**RELEASED FOR  
 FABRICATION / INSTALLATION**  
 PPPL Drafting:

Oak Ridge National Laboratory managed for the DEPARTMENT OF ENERGY under U.S. GOVERNMENT contract DE-AC05-00OR22725 UT-BATTELLE, LLC, Oak Ridge, Tennessee PROJECT NAME						
NATIONAL COMPACT STELLERATOR EXPERIMENT VACUUM VESSEL PERIOD INSPECTION AND LEAK CHECK ASSEMBLY						
VERSION NO.	PLANT	BLDG	FL	SHT OF	TYPE	CLASS
5	X-10	5700	3	2 19	A	U
RELEASE LEVEL		SE120-004			REV	
Fabrication					2

TYPICAL PORT 8A AND 8B  
SECTION PORT08-PORT08

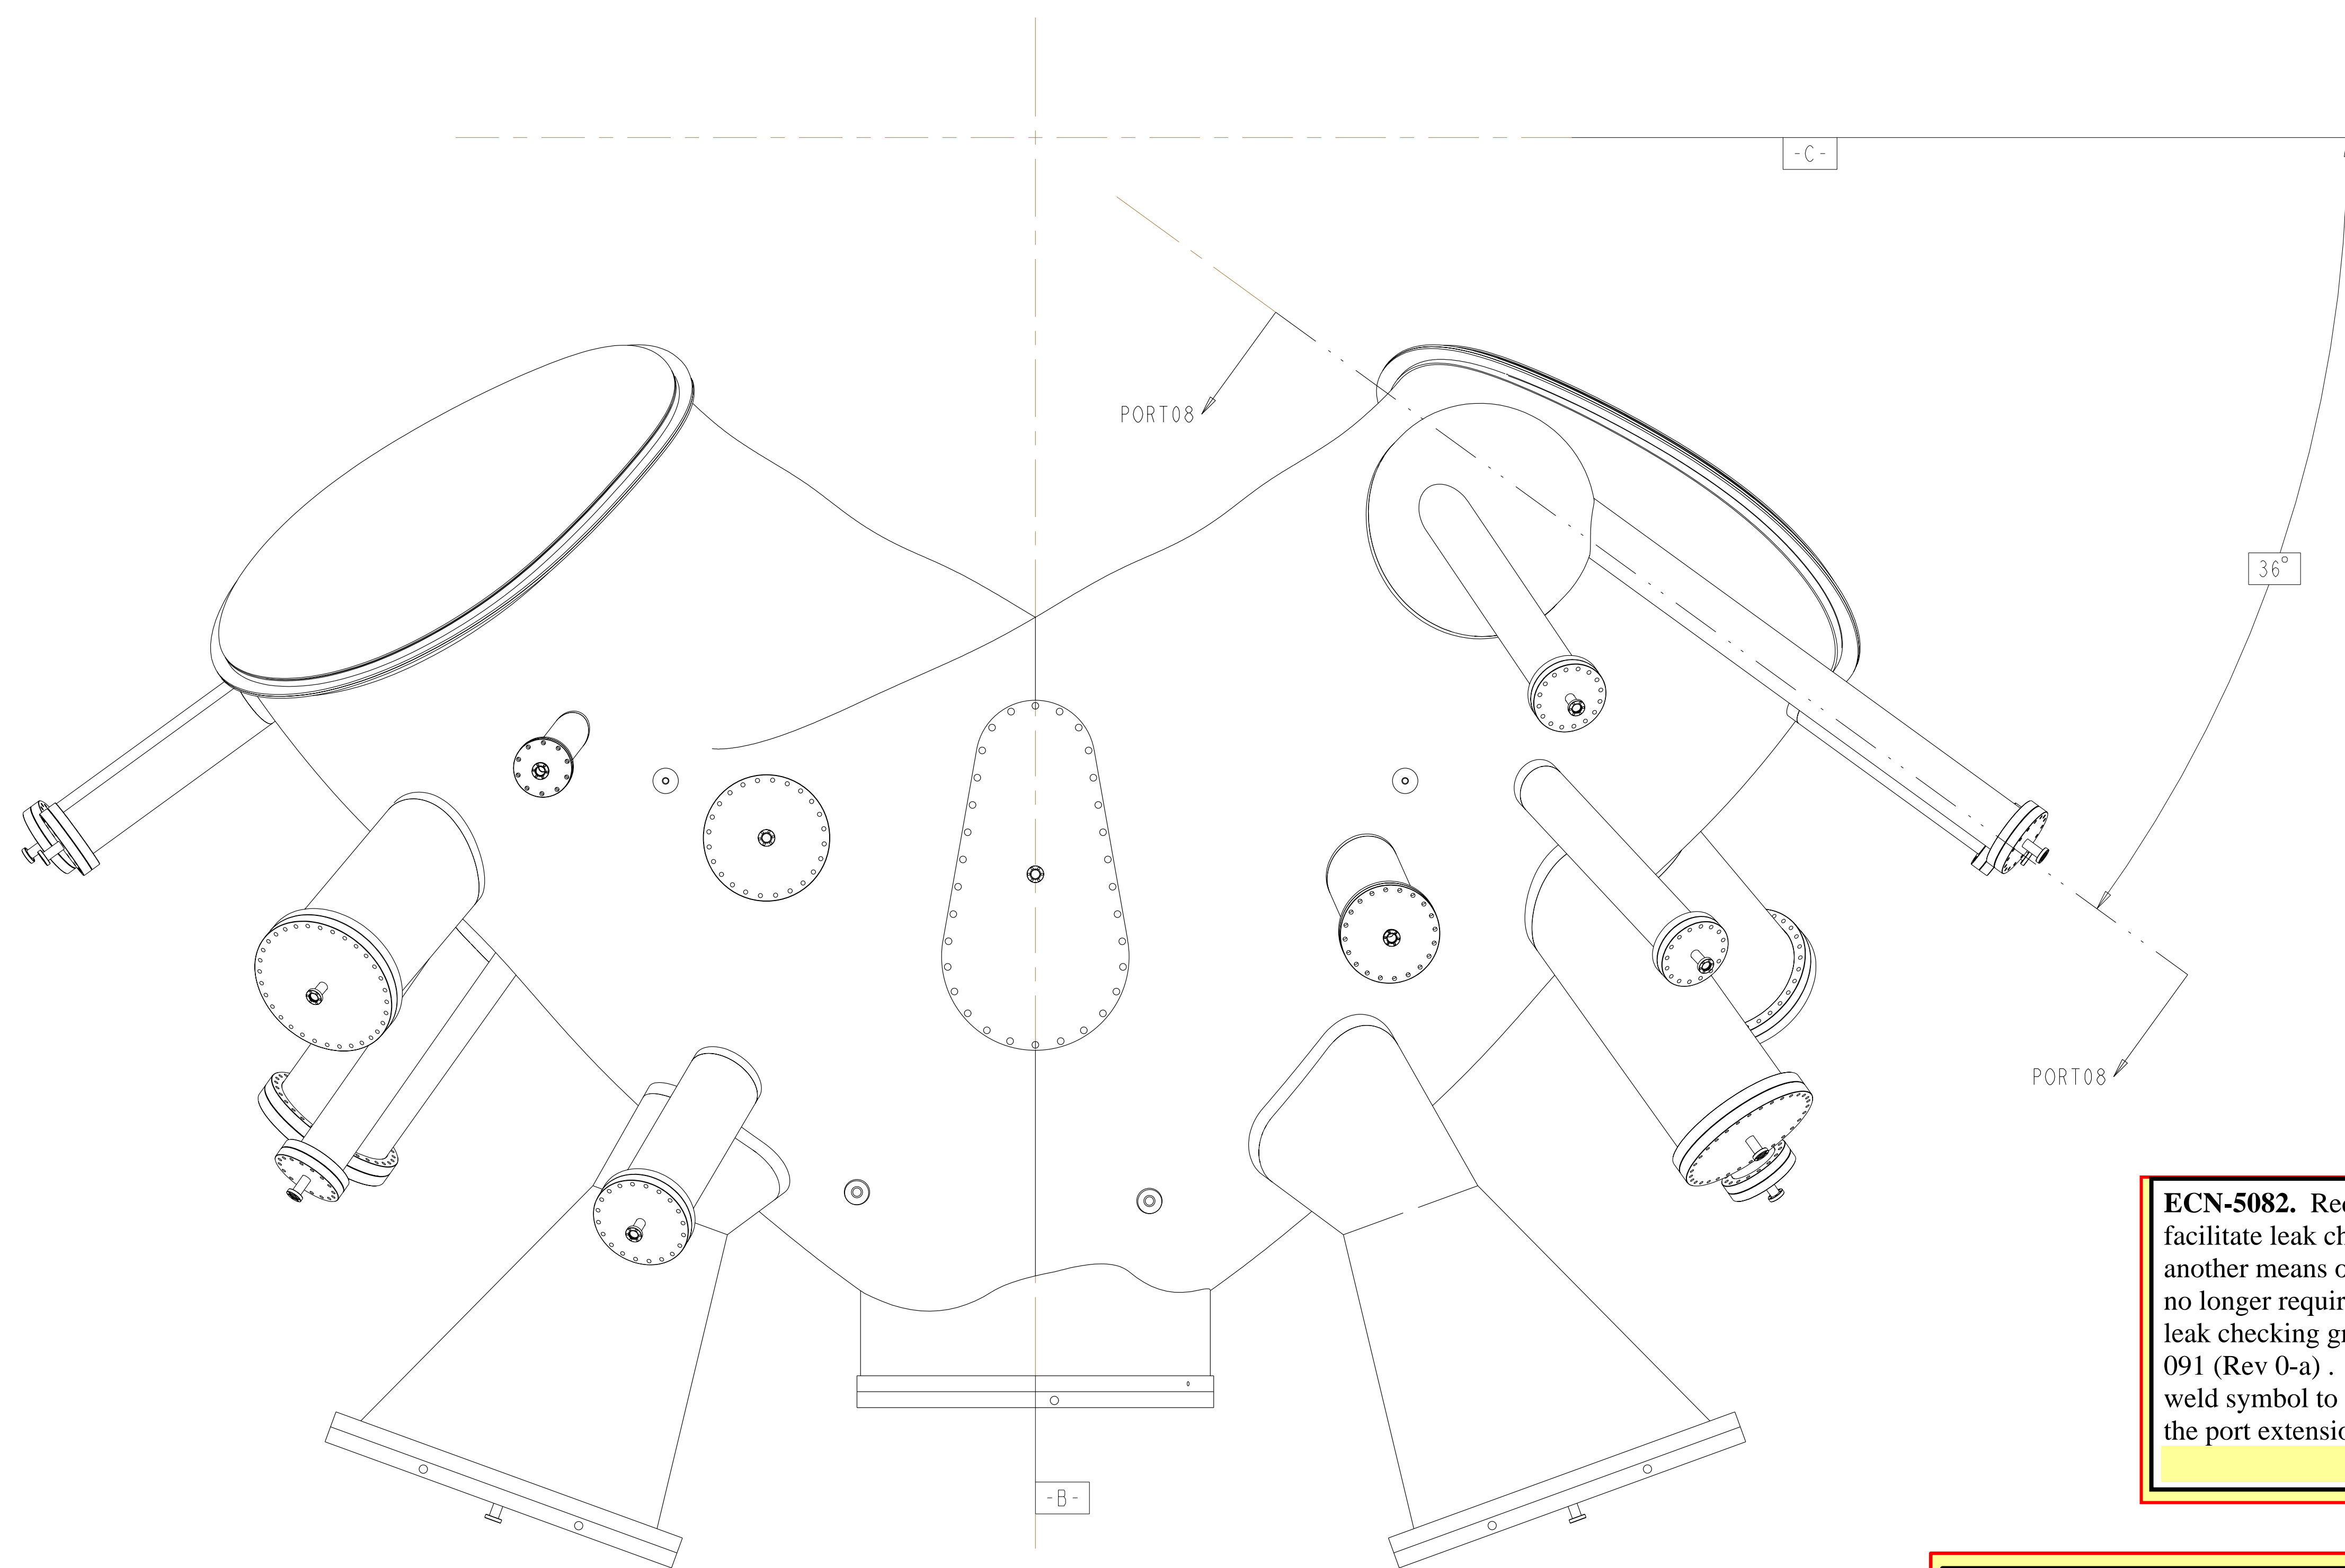
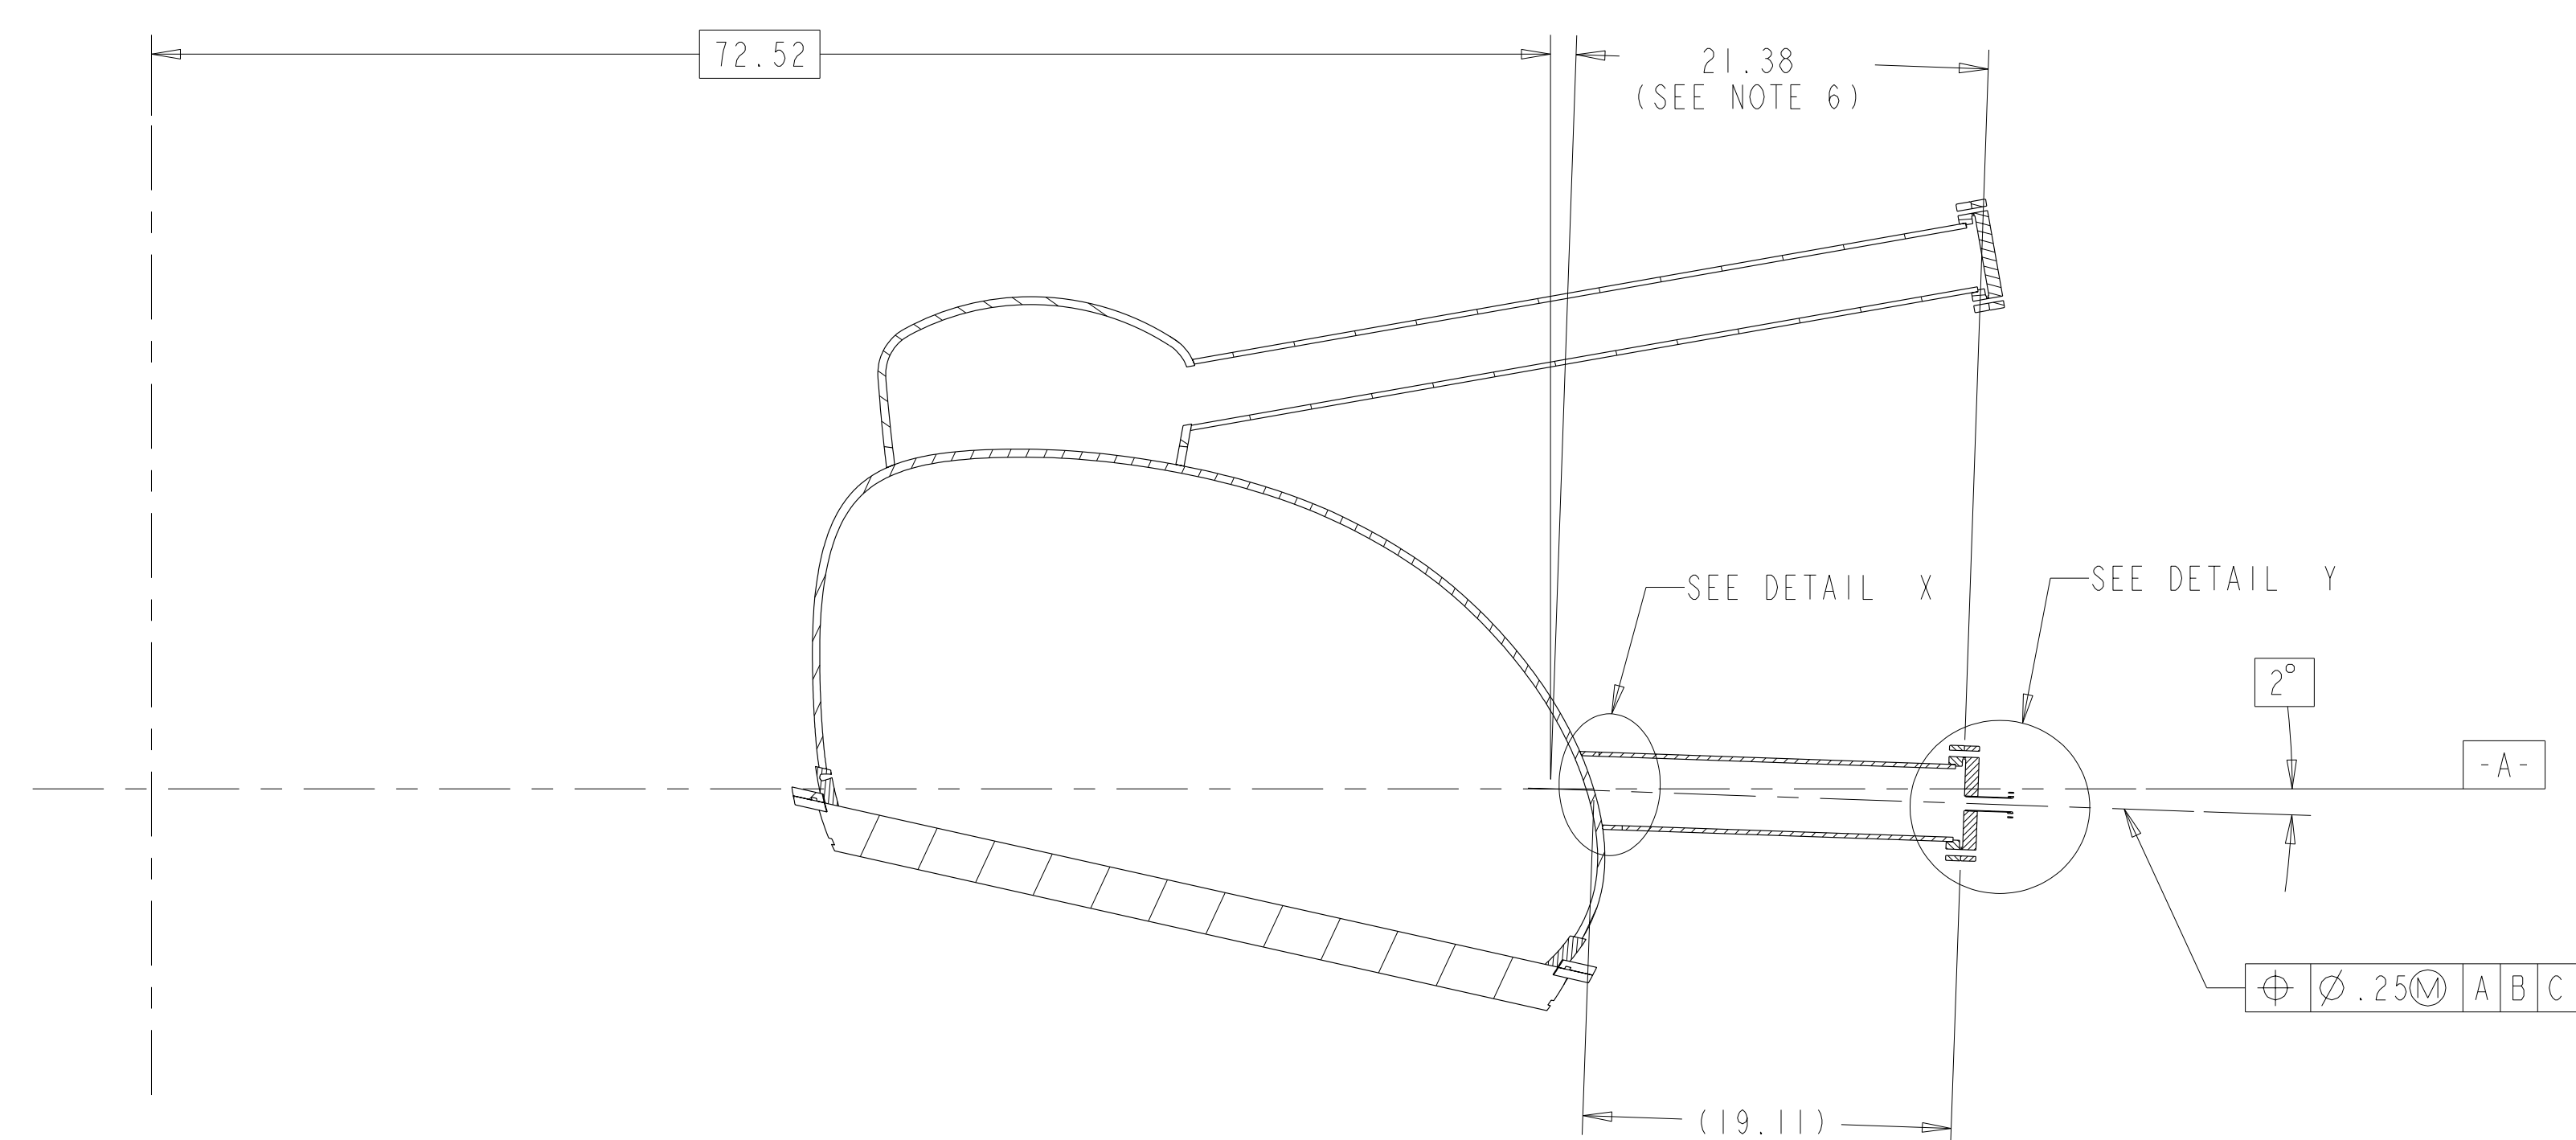
**ECN-5082.** Requirement originally included grooves to facilitate leak checking by vendor. However, vendor elected another means of leak checking and therefore the grooves are no longer required. Specifically, this ECN eliminated the leak checking groove on SE121-014 (Rev 1-c) and SE1221-091 (Rev 0-a). Additionally, this ECN added a missing weld symbol to SE121-004 (Sheets 4 through 19) for joining the port extensions to the vessel (Rev 2-d).  
**(See ECN-5082 for details)**

**Rev 2-e: ECN-5021 (RFD-12-017) approved alternate methods for welding the port extensions to the VVSA (See ECN-5021 for details). - Only applicable to VVSA #3 - VVSA #1 and #2 covered by NCR 19464.**
